PIC18F47J13 Family Silicon Errata and Data Sheet Clarification

Data Sheet Clarifications

The following typographic corrections and clarifications are to be noted for the latest version of the device data sheet (DS39974A):

FIGURE 2-3 FREQUENCY vs. ESR PERFORMANCE FOR SUGGESTED VCAP

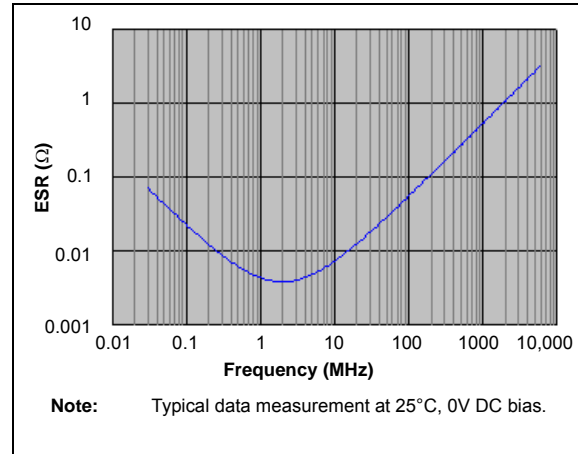
Section “2.4 Voltage Regulator Pins (VCAP/VDDCORE)” has been replaced with a new and more detailed section. The entire text follows:

Designers may use [Figure 2-3](#) to evaluate ESR equivalence of candidate devices.

On “F” devices, a low-ESR ($< 5\Omega$) capacitor is required on the VCAP/VDDCORE pin to stabilize the voltage regulator output voltage. The VCAP/VDDCORE pin must not be connected to VDD and must use a capacitor of 10 μF connected to ground. The type can be ceramic or tantalum. Suitable examples of capacitors are shown in [Table 2-1](#). Capacitors with equivalent specifications can be used.

It is recommended that the trace length not exceed 0.25 inch (6 mm). Refer to [Section 30.0 “Electrical Characteristics”](#) for additional information.

FIGURE 2-4 DC BIAS VOLTAGE vs. CAPACITANCE CHARACTERISTICS

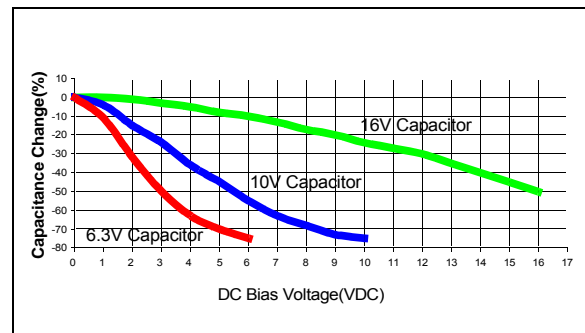
A typical DC bias voltage vs. capacitance graph for 16V, 10V and 6.3V rated capacitors is shown in Figure 2-4.

When selecting a ceramic capacitor to be used with the internal voltage regulator, it is suggested to select a high-voltage rating, so that the operating voltage is a small percentage of the maximum rated capacitor voltage. For example, choose a ceramic capacitor rated at 16V for the 2.5V core voltage. Suggested capacitors are shown in Table 2-1.
